4052/54 VERSION 4.1 FIRMWARE

4052/54 +15 REGULATOR CIRCUIT #M39801

Figure 1 Schematic 1-1 Power Supply 4052 Service Manual

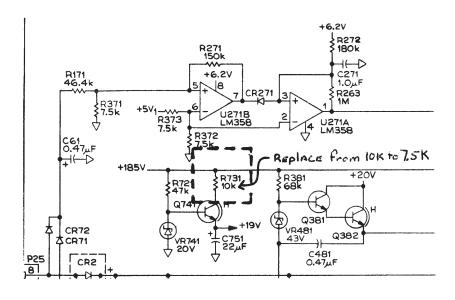
The +15 supply goes out of regulation at low line. The problem is caused by insufficient current capability of the +19V supply used to supply the +15V regulator circuit. This problem could be causing the 4052/54 to randomly lock-up customers units.

The Mod to solve this problem is as follows: (refer to figure 1)

Change R731 of the 670-5623-00 regulator board from a 10K (321-0289-03) resistor to a 7.5K. (321-0277-00)
